Customer	: CU-DAR001 Dart Helicopters Services	Drawing Name	: HELI UTILITY BASKET LH/RH 350/355
Job Number	: 36413		
Estimate Number	: 10208		
P.O. Number	: N/A	Part Number	: D350607043
First Issue	: 12/18/2007 S.O. No. : N/A	Drawing Number	: D350-607 REV F P7-9
Prsht Rev.	: NC	Project Number	: N/A
First Issue	: N/A	Drawing Revision	: F
Previous Run	: 36412	Material	: N/A
Written By	: _____	Due Date	: 1/18/2008
Checked & Approved By	: <u>12/27/07</u>	Qty:	1 Um: Each
Comment	: Est Rev:E as Per DSI9318 06-01-24 JLM

DESIGN <i>CP</i>	DRAWN BY <i>CP</i>	DART AEROSPACE LTD HAWKESBURY, ONTARIO, CANADA	
CHECKED <i>[Signature]</i>	APPROVED <i>[Signature]</i>	DRAWING NO. DSI 9318	REV. A SHEET 1 OF 1
DATE 06.01.06		TITLE WASHER ADDITION	SCALE NTS
A	06.01.06	NEW ISSUE

DART SERVICE INSTRUCTION

TO AMEND INSTALLATION INSTRUCTIONS D350-607 REV. F

Figure 5- Basket Replacement Parts
(D350-607-043 Heli-Utility-Basket™)

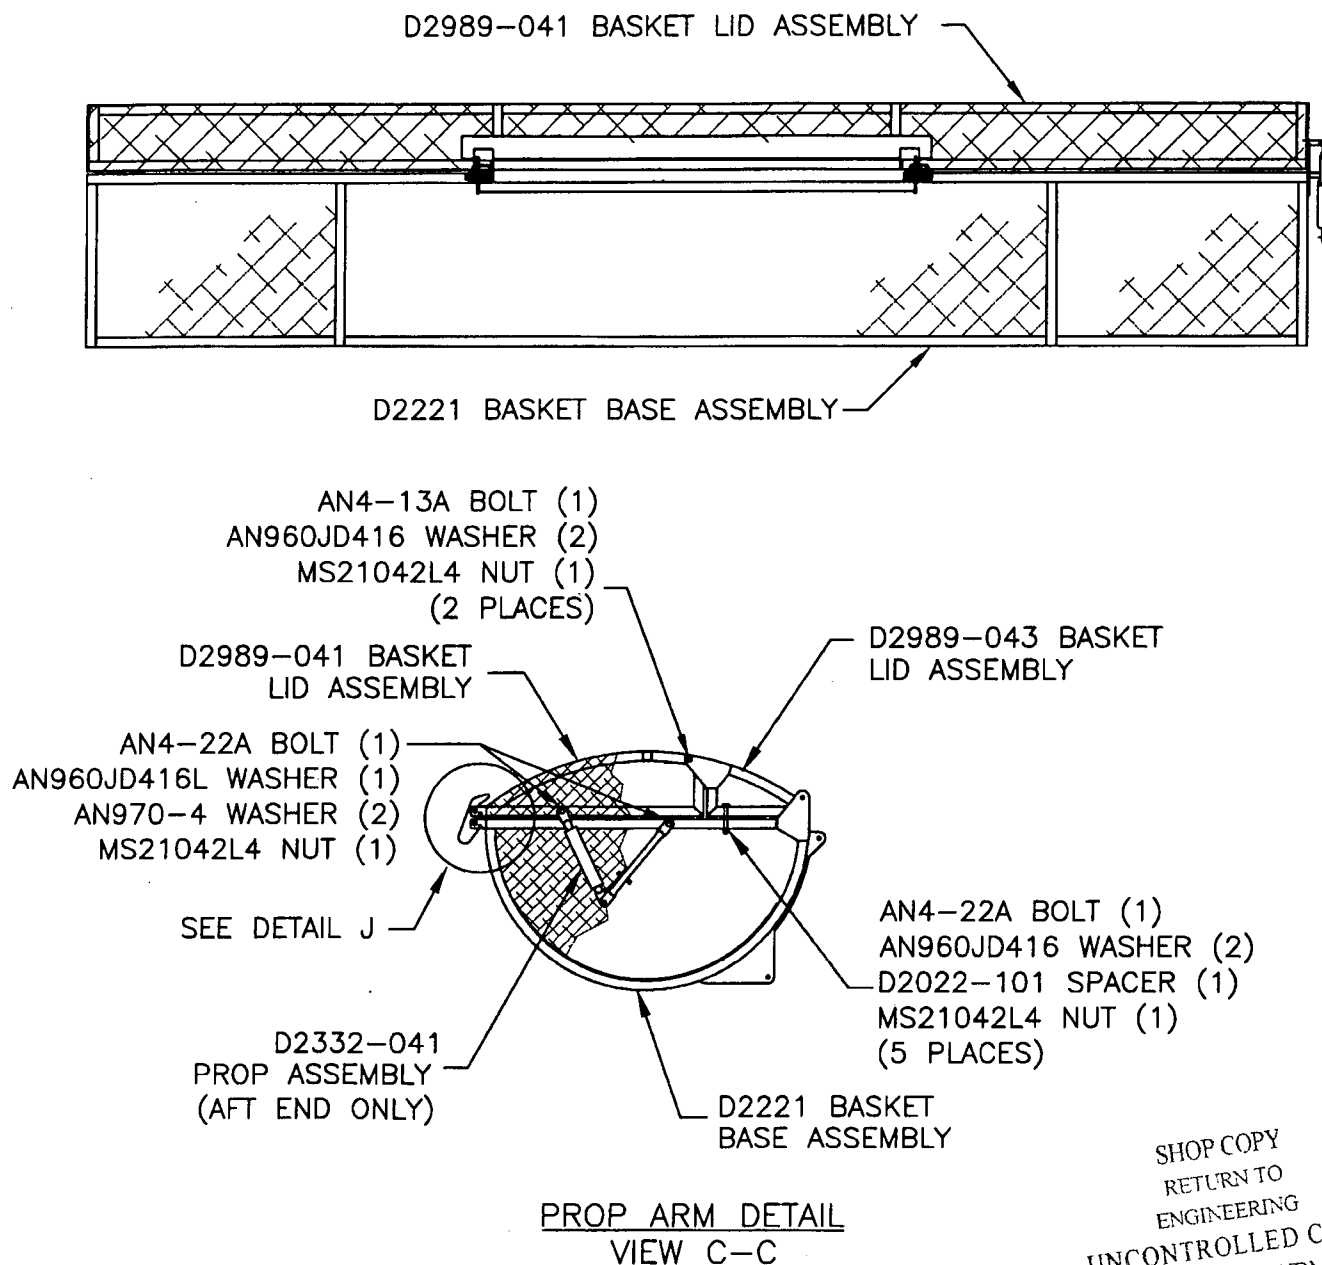
To reduce the possibility of damaging the finish, a **NAS1515H4** washer (2 places) has been added between the hinge plate and basket frame on the **D350-607-043/-047 Heli-Utility-Basket**.

AN4-13A BOLT (1)
AN960JD416 WASHER (1)
HINGE PLATE (REF)
NAS1515H4 WASHER (1)
BASKET FRAME (REF)
AN960JD416 WASHER (1)
MS21042L4 NUT (1)
(2 PLACES)
